Model type:
LI700DUO

Commercial code:
F029515

Notices

n1045069: Modification of racks and dispenser lid on EVO3 dishwashers

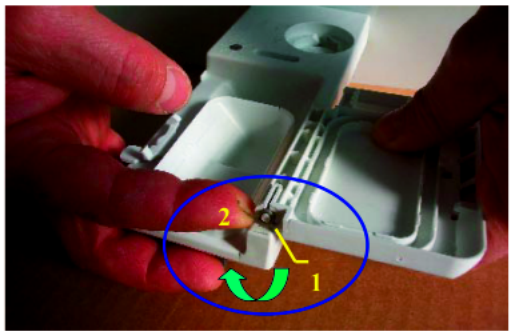
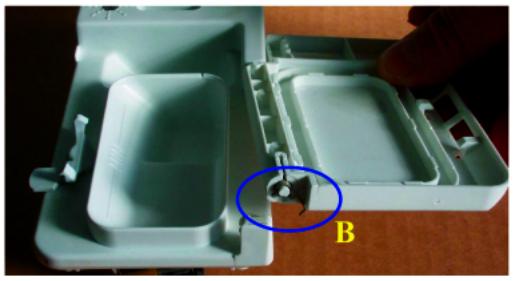
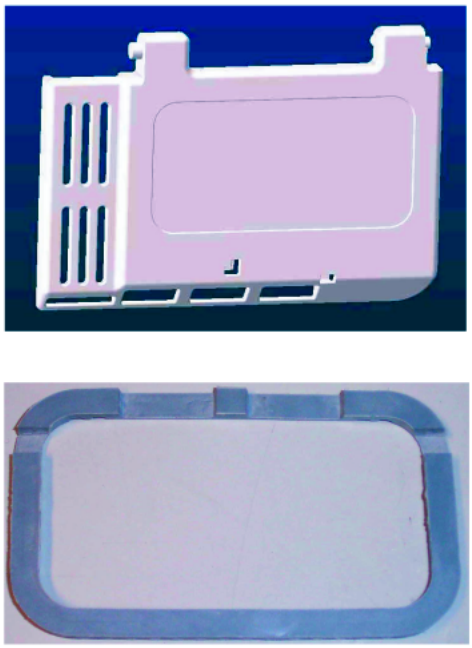
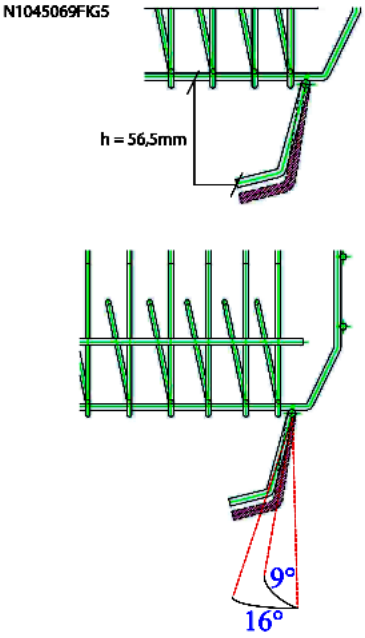
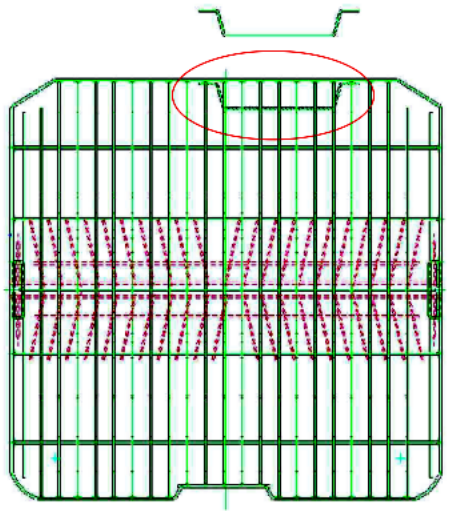
To obtain better dissolving of the detergent during the wash cycle, the following modifications have been made to EVO3 dishwashers:
- new dispenser lid, replacement code 098134 (see figure N1045069FIG4) created;

- upper racks modified with lid catch angle changed from 9° to 16° (see figure N1045069FIG5);
- MultiSystem lower racks modified with insertion of a spacer wire at the electric dispenser (see figure N1045069FIG6).

Lid installation instructions:
1) prise the lid out of the dispenser seat using a small screwdriver at point A (figure N1045069FIG1);
2) replace the lid, checking that release spring B (figure N1045069FIG2) is in place; before fitting the new lid load the spring from position 1 to position 2 (figure N1045069FIG2);
3) fit the lid in its special seat and check for correct operation (figure N1045069FIG3).
Lid closing may be harder for the first few cycles after replacement, due to settling of the material.

The upper and lower racks have the same spare part codes as the premodification items; Replacements Warehouse stocks have been replaced.

N1045075FIG1

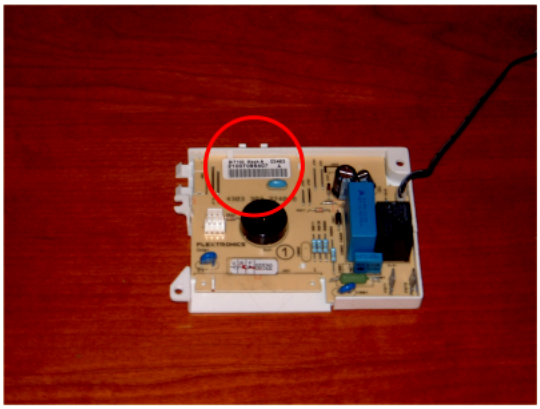
Replacement of Service codes 097431 and 095281 with 097481 is only possible with BIT 100 "E2" TIMER card code 210097877.02.

The card code is printed on an adhesive label located on the box or on the card itself (illustration N1045075FIG1).

N1045083FIG1

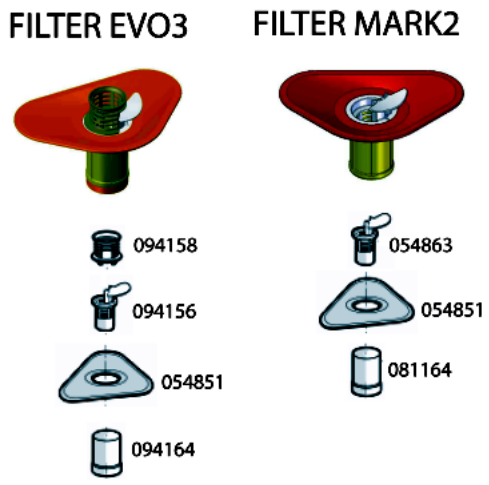
n1045083: Modification of filters on EVO3 60 cm dishwashers

All dishwasher models affected by this modification have been equipped with the items listed below, in order to solve the drain pump clooging problem.

Introduction of:
Cylindrical plastic filter code 081164
Central filter code 054863

Elimination of:
Cylindrical plastic filter code 094164

Central filter code 094156
Central filter grid code 094158

n1045085: Introduction of new litre counter turbine integrated on air-break.

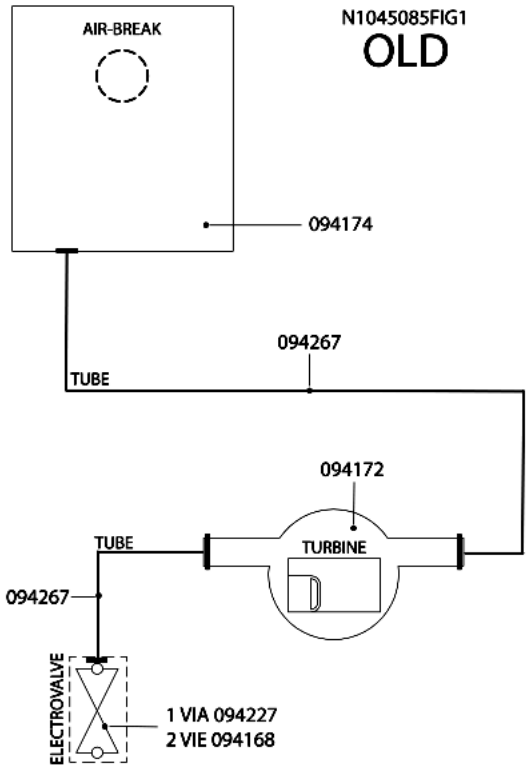
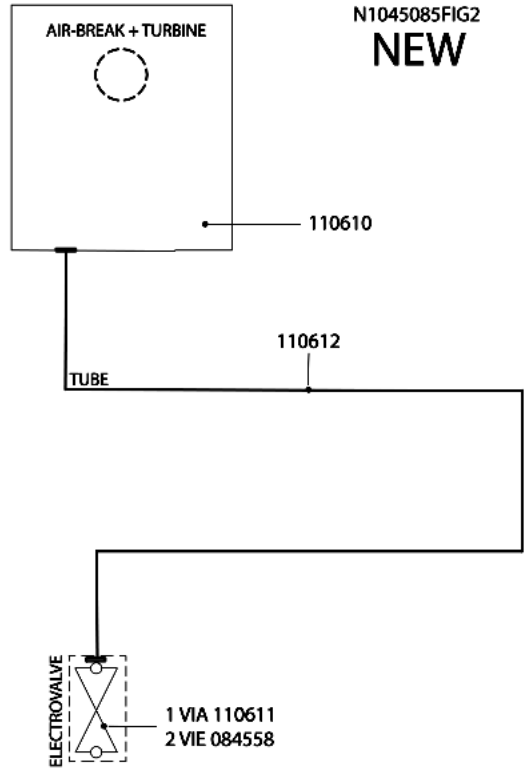
All dishwashers affected by this note have been equipped with a new litre counter turbine on the air-break.
Picture N1045085FIG1 illustrates the premodification structure, picture N1045085FIG2 the new structure.

AIR-BREAK:
new 110610;
premodification 094174;
the new item features a new integrated litre counter turbine and its water supply hose has a smaller diameter.

SOLENOID VALVES:
new:
1-WAY code 110611;
2-WAY code 084558(Rohs 143737);
premodification:
1-WAY code 094227;
2-WAY code 094168;
the new solenoid valves have a smaller diameter drain hose fitting.

HOSES:
new solenoid valve hose/air-break code 110612;
premodification turbine hose/air-break code 094267;
premodification solenoid valve hose/air-break code 094267;
the new hose has a smaller internal diameter.

N1045076FIG1

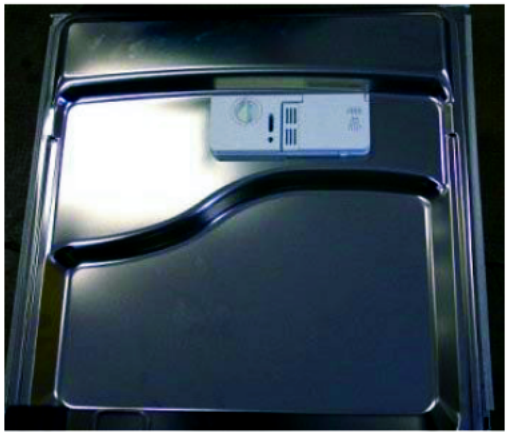
n1045099: Different position of electric distributor.

The position of the electric distributor has been changed as shown in the attached illustration.
The new machines have a new industrial code.

Introduced items:
C00118140 upper rack
C00109698 inside door

Premodification items:
C00114486 upper rack
C00095276 inside door

N1045136FIG1

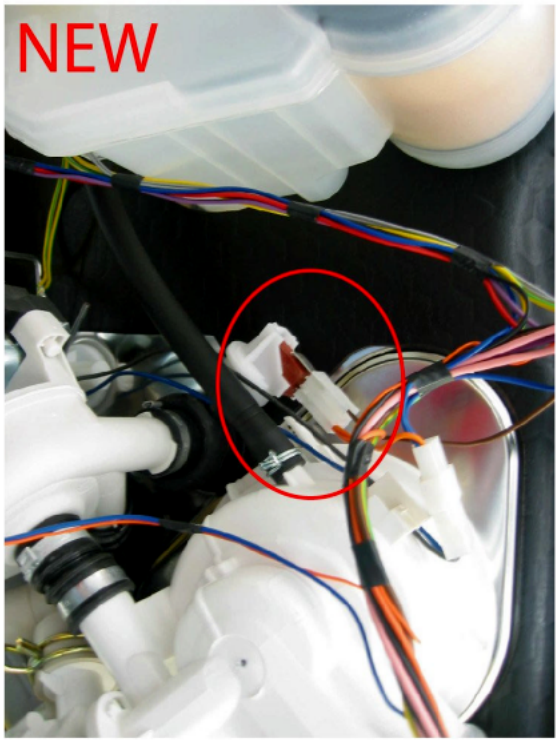
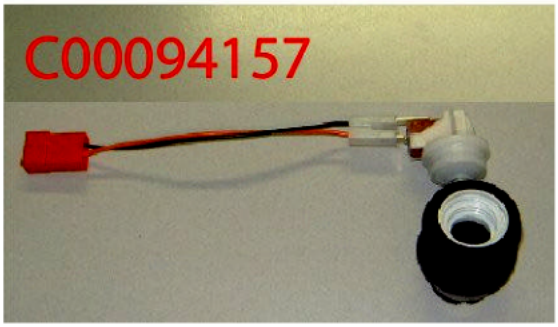
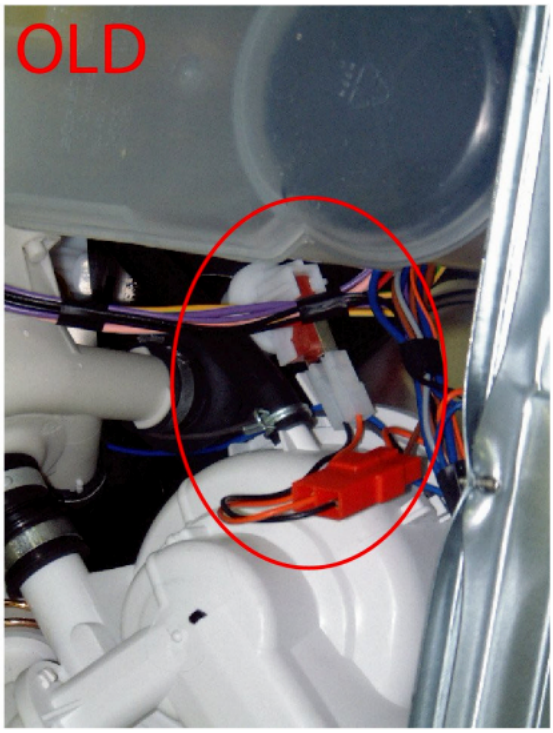
In modified products the connector going to the high pressure sensor is part of the wiring assembly (see picture N1045136FIG1).
In premodification products the high pressure sensor is connected to the wiring assembly by a cable that is part of code C00094157 (see pictures N1045136FIG2-3).

New parts
Wiring
C00142435 - high pressure sensor

Premodification parts
Wiring
C00094157 - high pressure sensor + cable

The new parts are not individually interchangeable with premodification ones.
